BVH ARCHITECTURE

ADDENDUM NO.: #01

DATE: 01/31/2024

PROJECT: Woodhouse Ford Pro: Building Improvements

1 FIRST FLOOR - DEMO PLAN
1/16" = 1'-0"

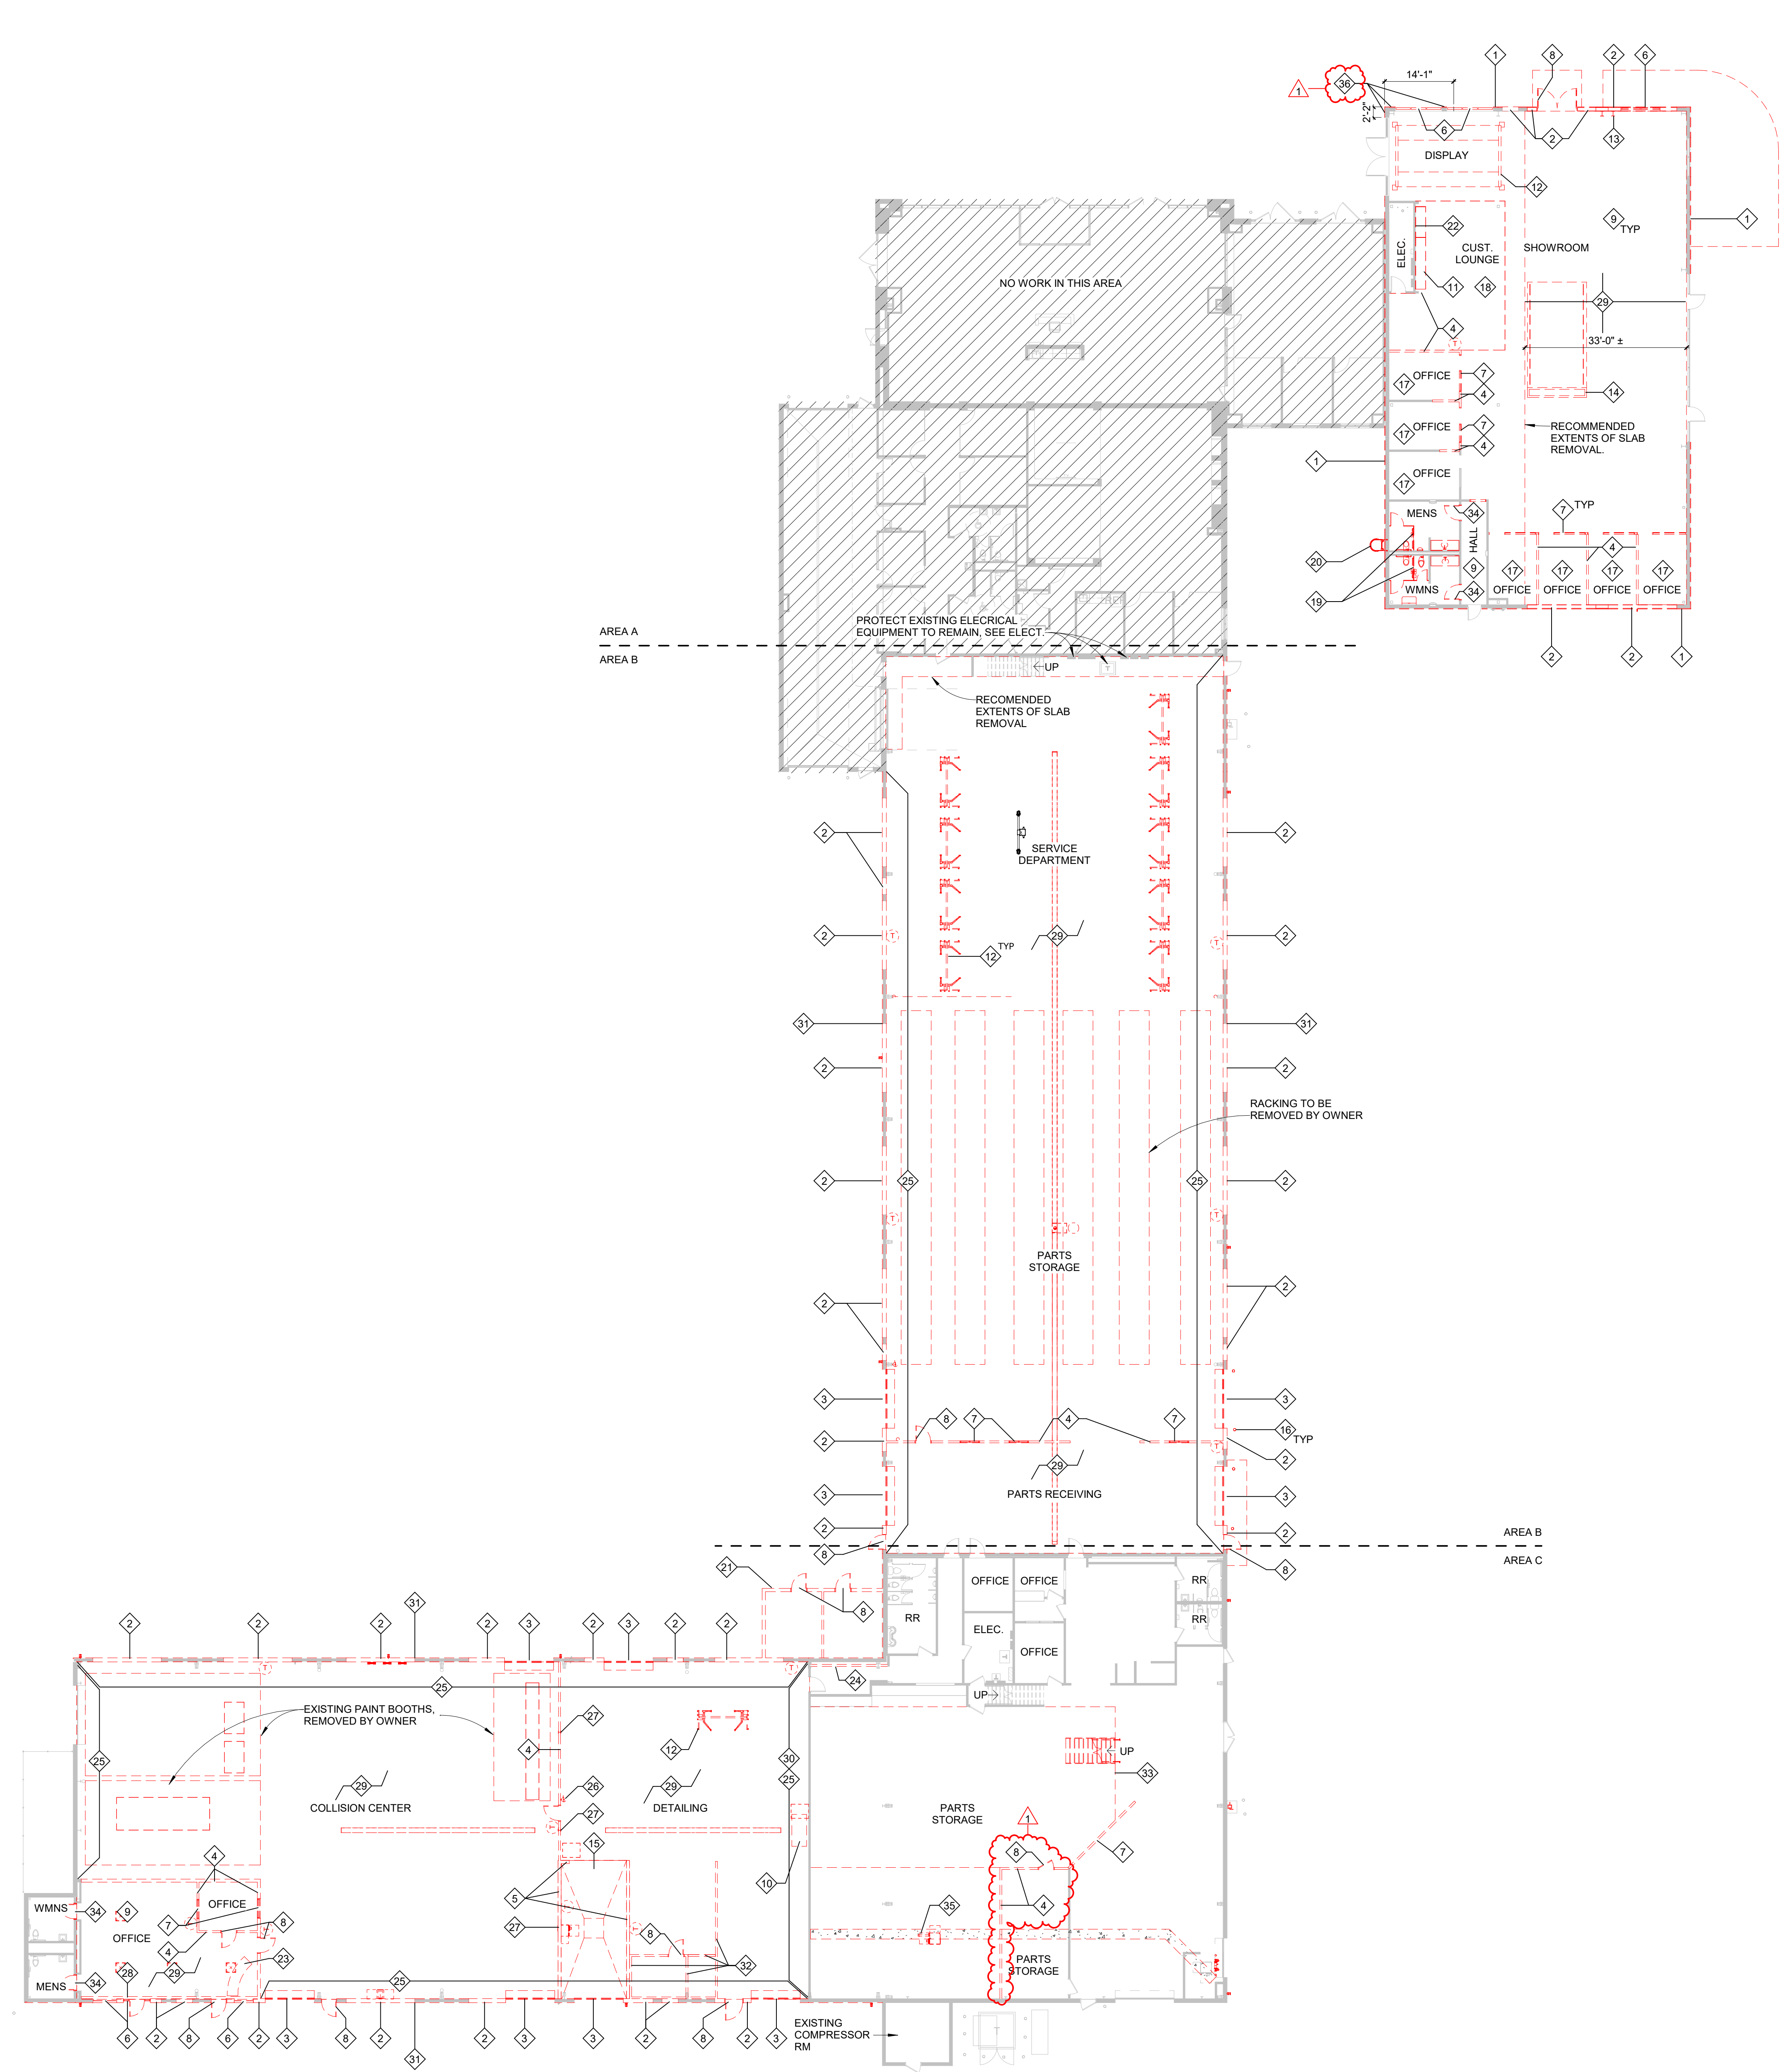
- a. 1 - FIRST FLOOR - DEMO PLAN
 - i. Add notes 8 and 4 to walls at the existing Parts Storage room.
 - ii. Added note 36 to the floor plan demo notes. "Remove existing 1/2" plywood sheathing as shown on drawing in prep for new 3/4" sheathing."

18 LOBBY ELEVATION - SOUTH
 1/4" = 1'-0"

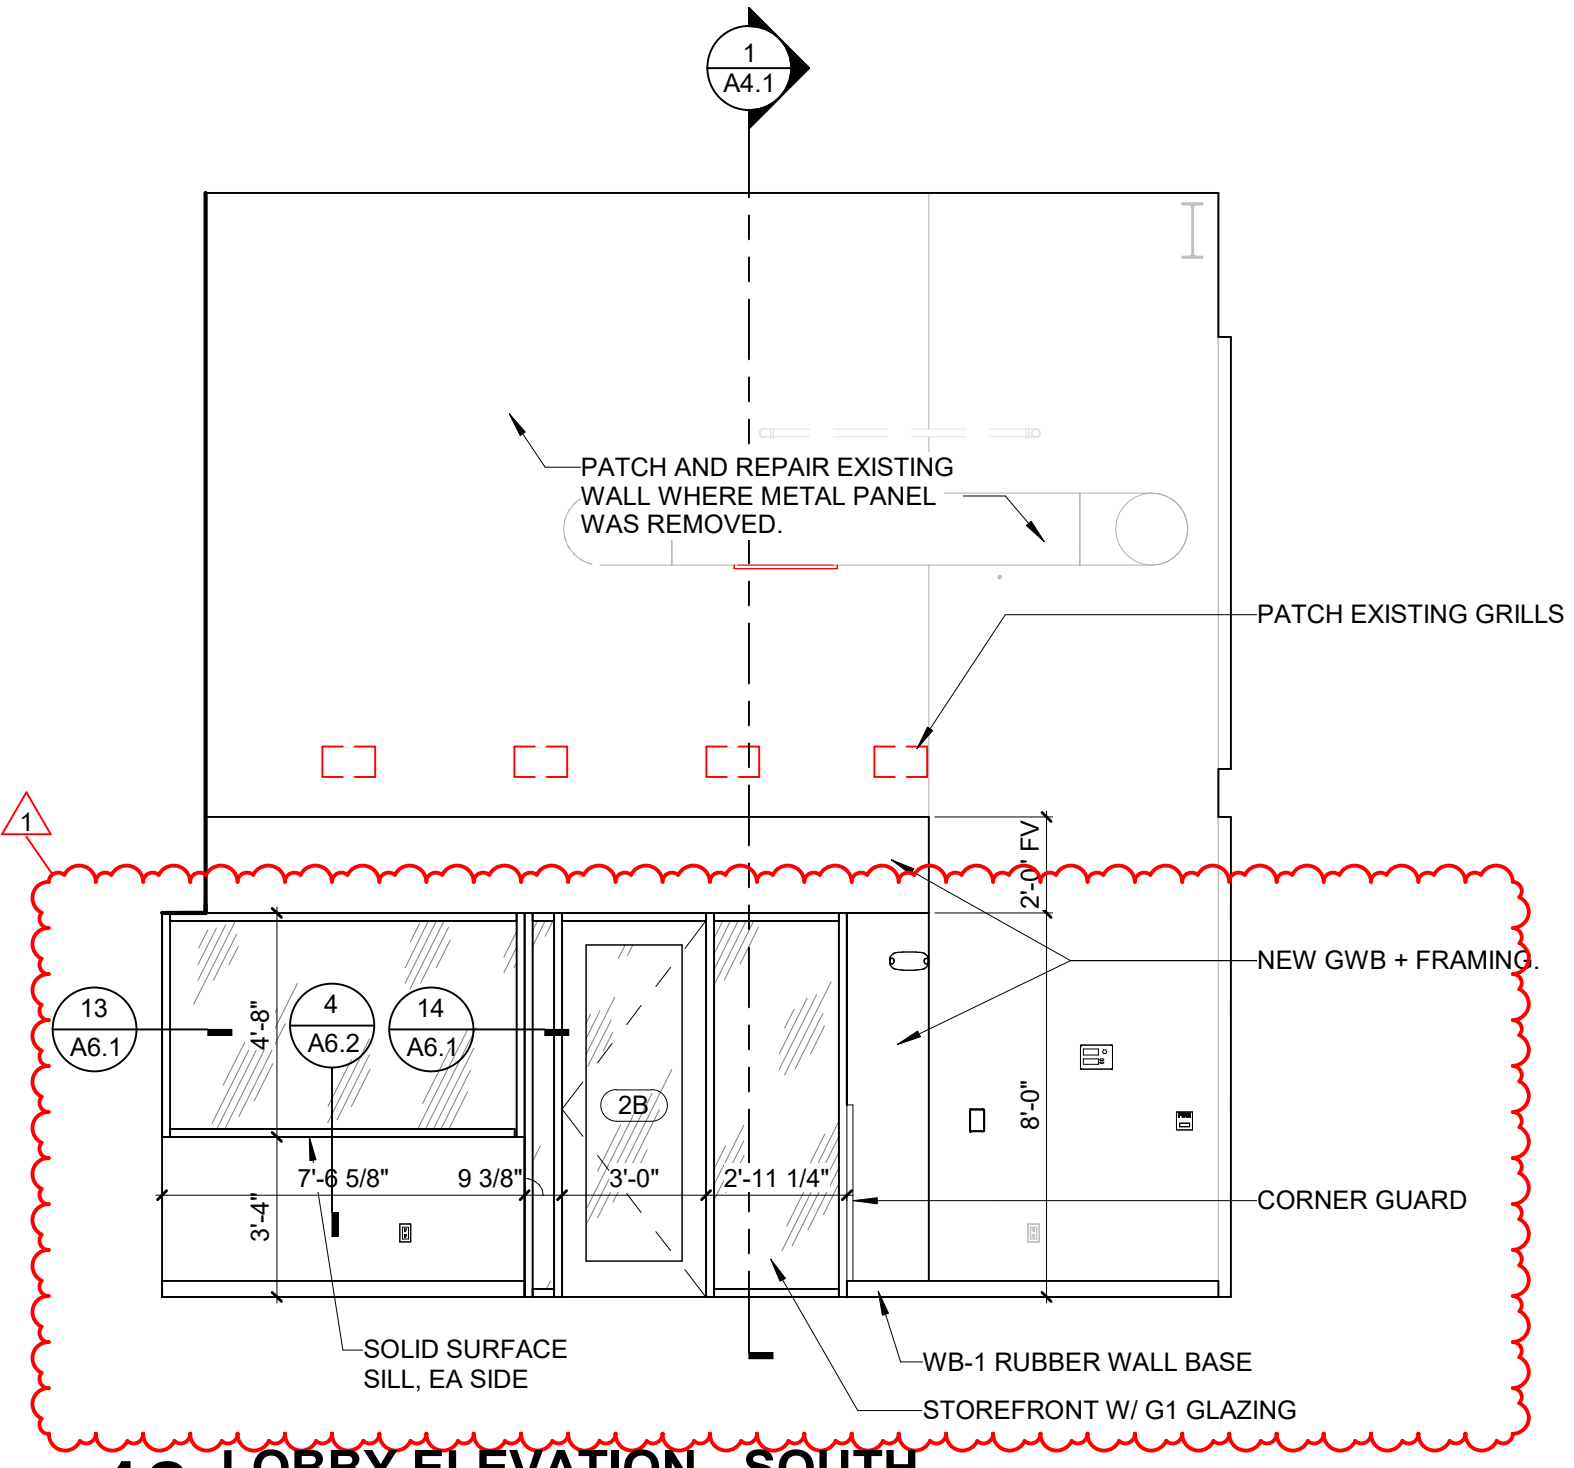
- b. 11 - LOBBY ELEVATION - NORTH
 - i. Revised control joint location
 - c. 18 - LOBBY ELEVATION - SOUTH
 - i. Added additional notes
 - ii. Added detail references and new detail 4/6.2.

1 RCP - AREA C
 1/8" = 1'-0"

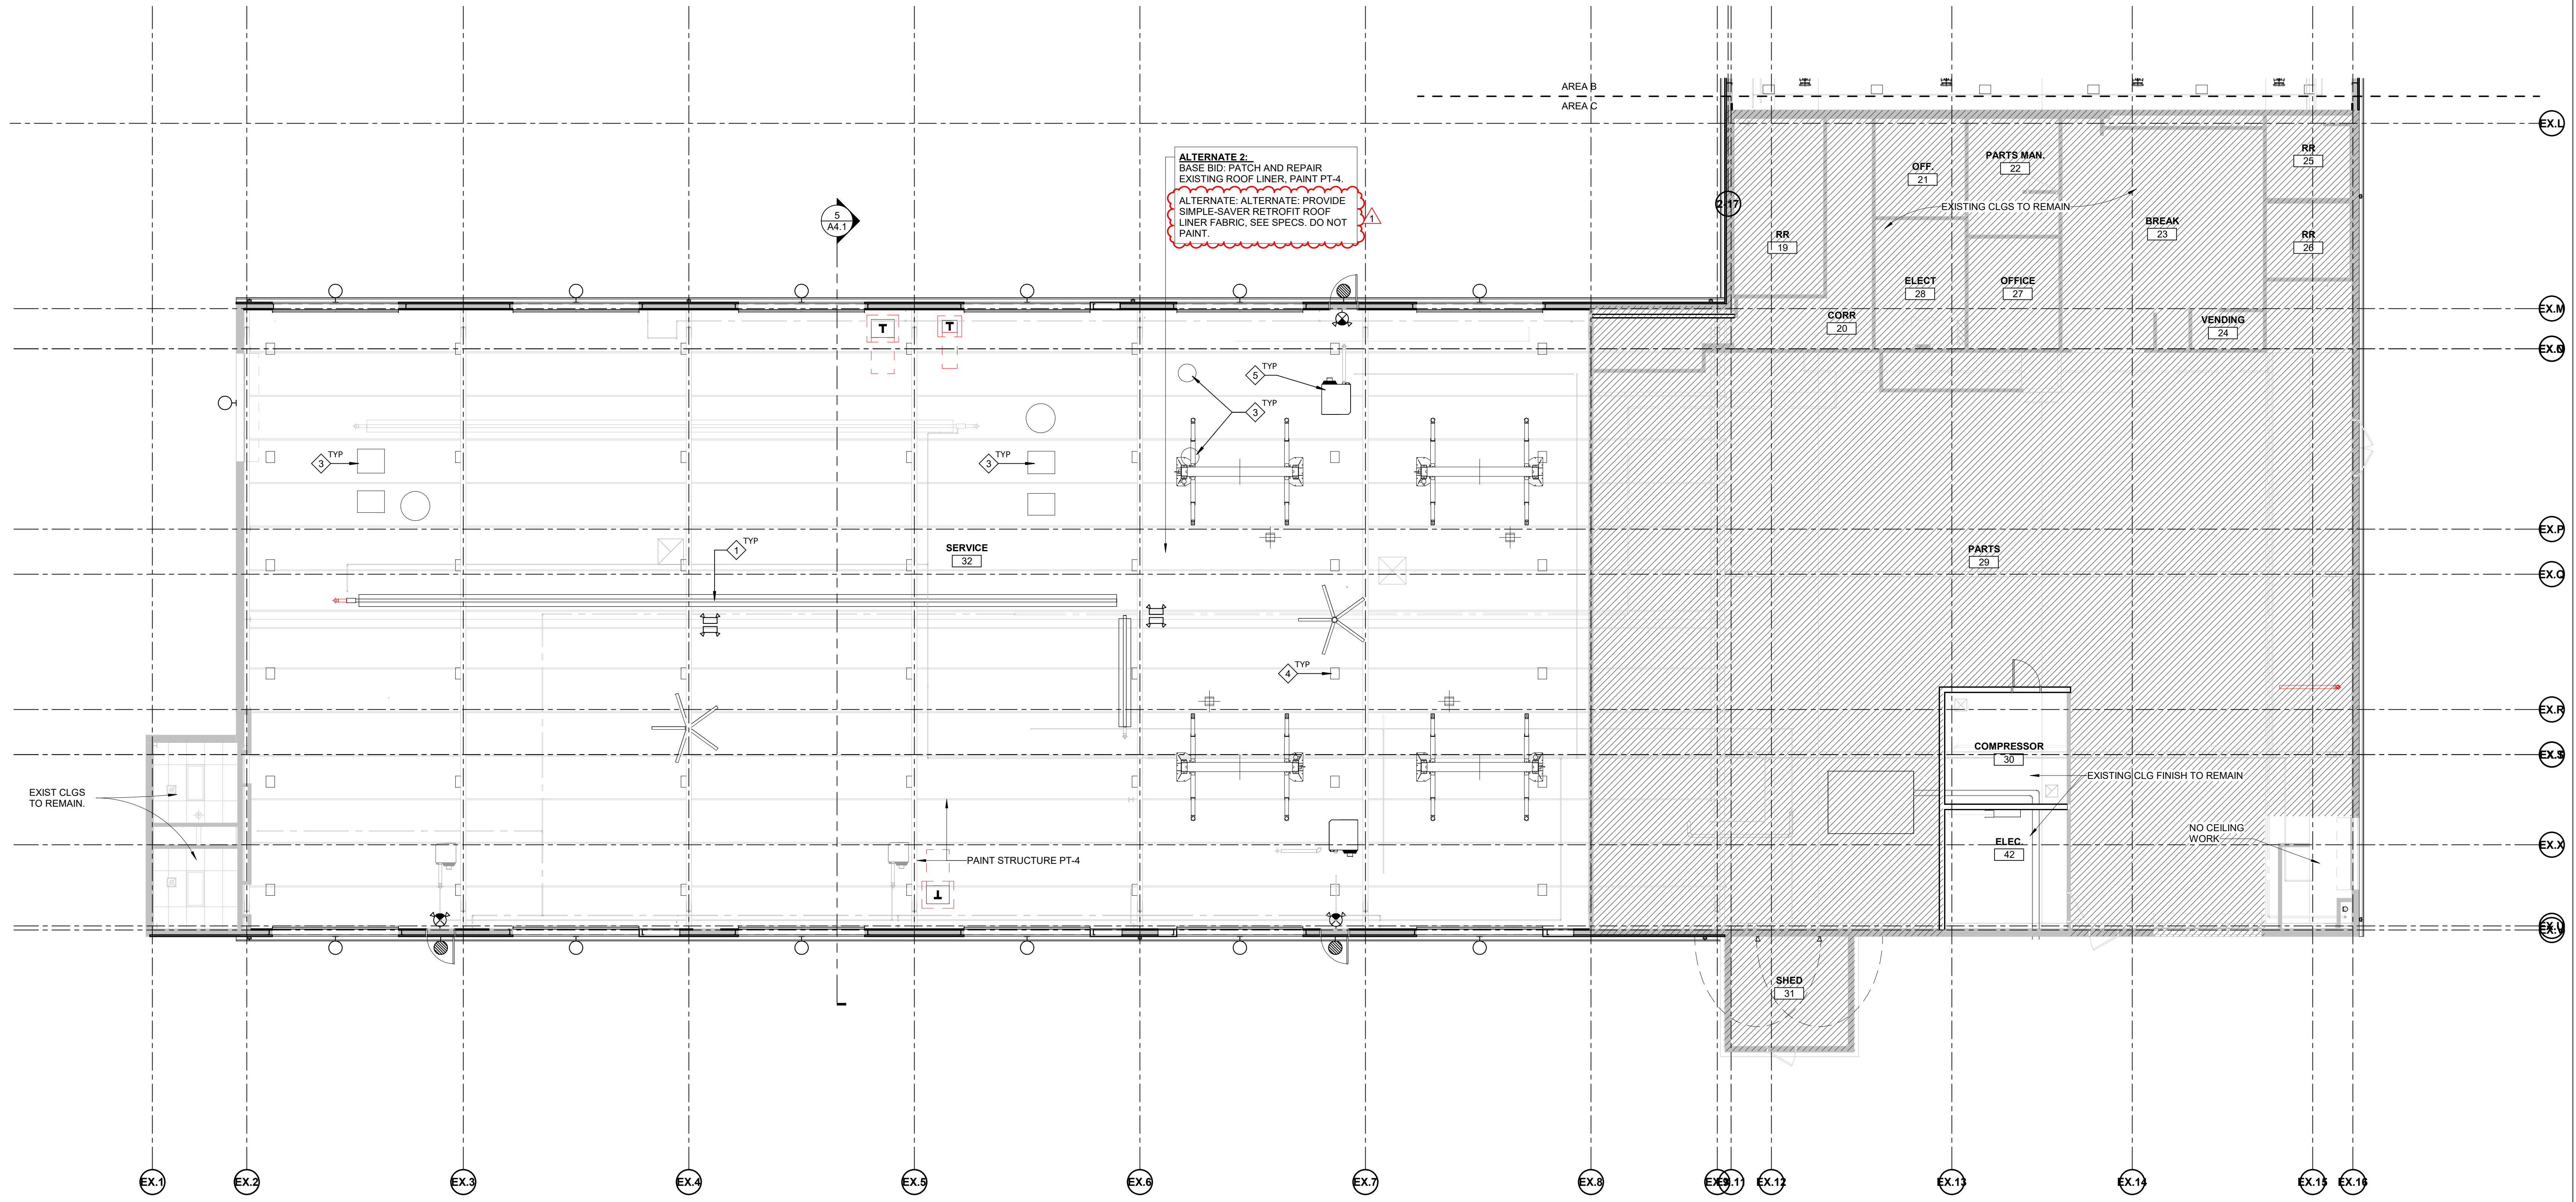
- 6. A2.1 - FIRST FLOOR RCP - AREA A&B**
- a. Revised Alternate 2 text. See attached specs.
- 7. A2.2 - FIRST FLOOR RCP - AREA C**
- a. Revised Alternate 2 text. See attached specs.

ALTERNATE 2:
 BASE BID: PATCH AND REPAIR EXISTING ROOF LINER, PAINT PT-4.
 ALTERNATE: ALTERNATE: PROVIDE SIMPLE-SAVER RETROFIT ROOF LINER FABRIC, SEE SPECS. DO NOT PAINT.

7 TYP EXT WALL ASSEMBLIES

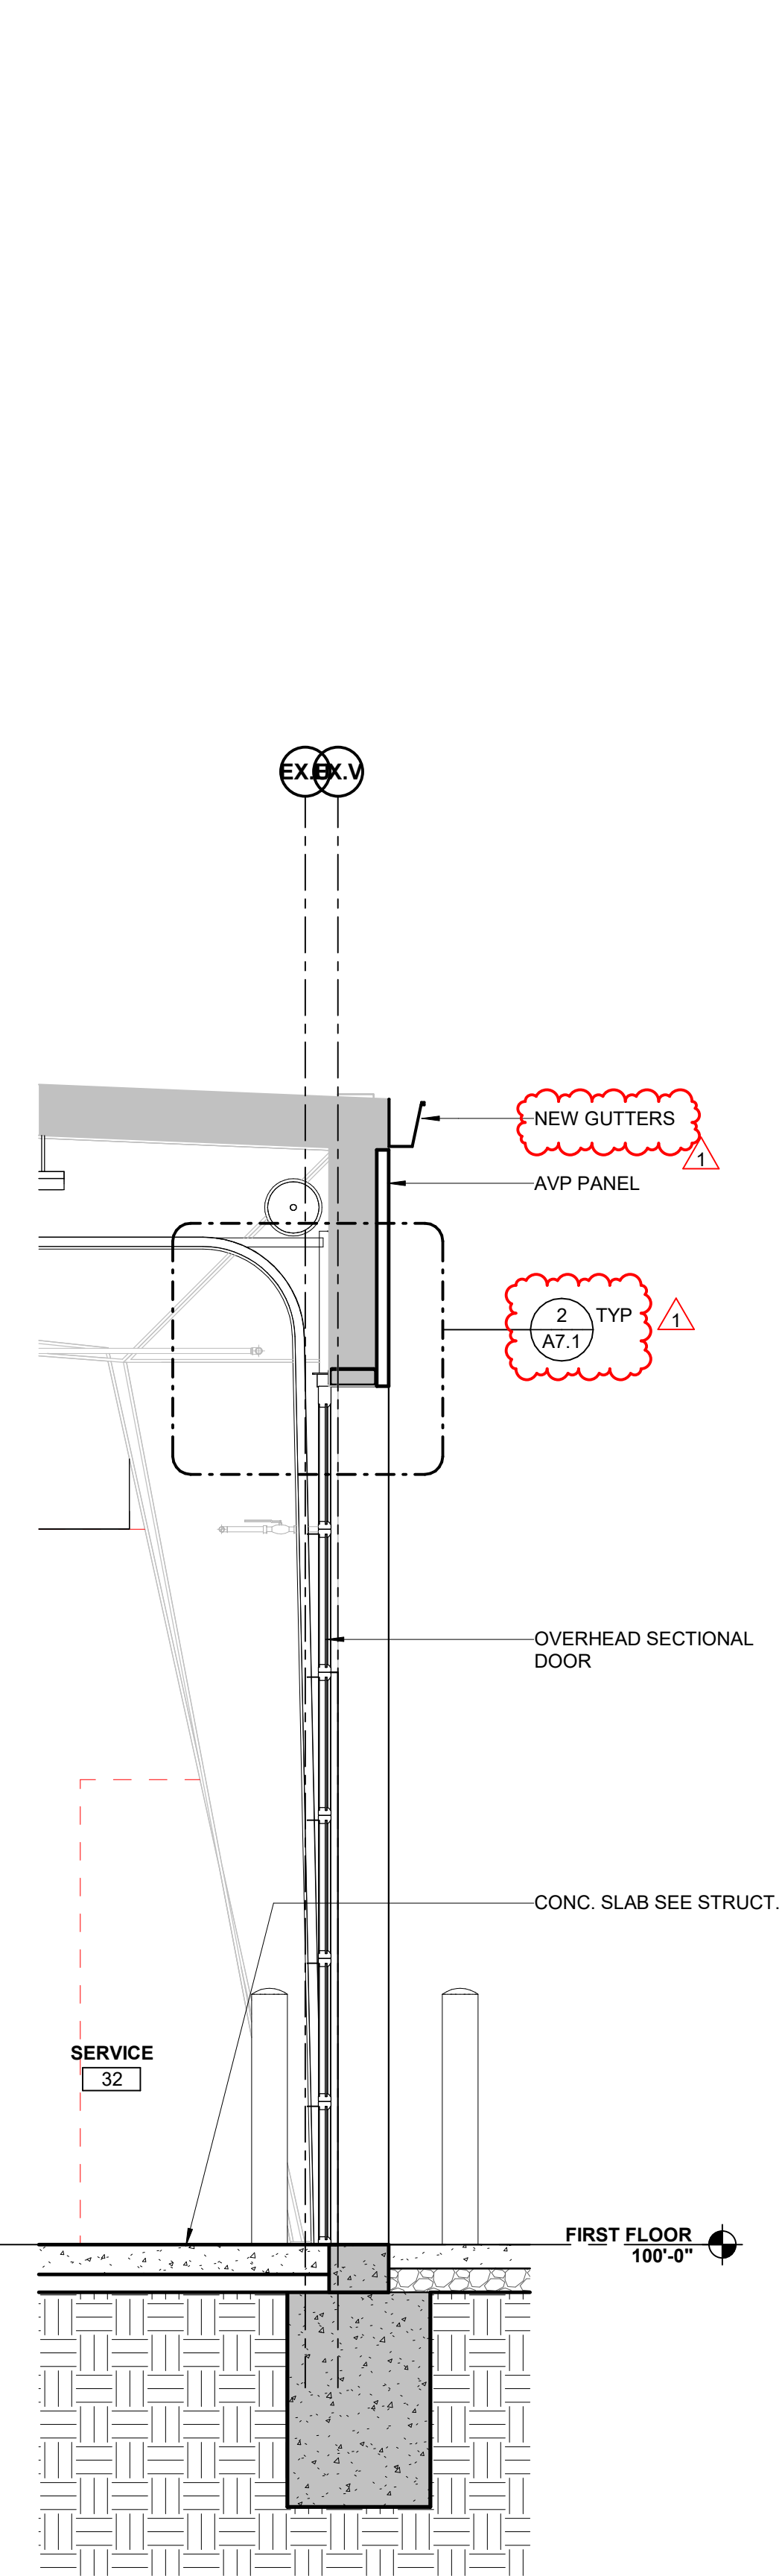
- b. 2 - WALL SECTION - FORD PRO WALL
 - i. Add note to provide WD blocking behind signage.
 - c. 7 - TYP EXT WALL ASSEMBLIES
 - i. Added note to provide FRT Plywood sheathing.
